# REGULATORY INFORMATION DISTRIBUTION SYSTEM (RIDS)

SUBJECT: Application for amends to License DPr-31 & DPR-41, upgrading  
 Tech Specs to include guidance of NUREG-0452, STS for  
 Westinghouse PWRs. Fee paid.

Re: Turkey Point Units 3 and 4  
Docket Nos. 50-250 and 50-251  
Proposed License Amendment  
Upgrade of Technical Specifications

Attachment I	Revised Technical Specifications
Attachment II	Safety Evaluation
Attachment III	Current/Revised Technical Specification Cross Reference

FIGURE 6.2-1  
OFF-SITE ORGANIZATION FOR FACILITY  
MANAGEMENT AND TECHNICAL SUPPORT

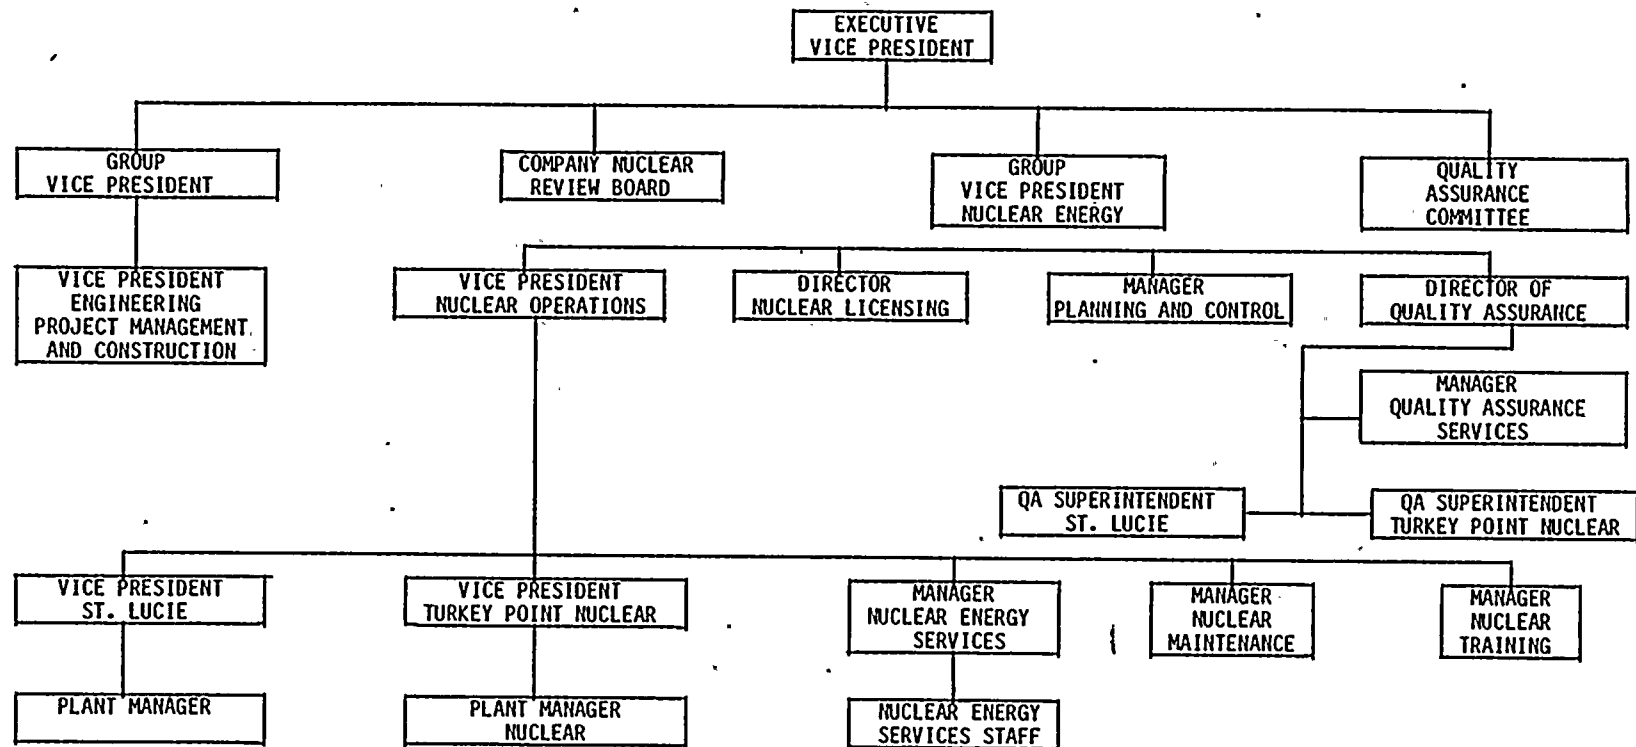
- a. The amendment revises Figure 6.2-1 identifying Offsite Organization for facility management and technical support. The revised figure adds organizational detail of management and technical support for the plant. Addition of this information is consistent with the Standard Technical Specification.
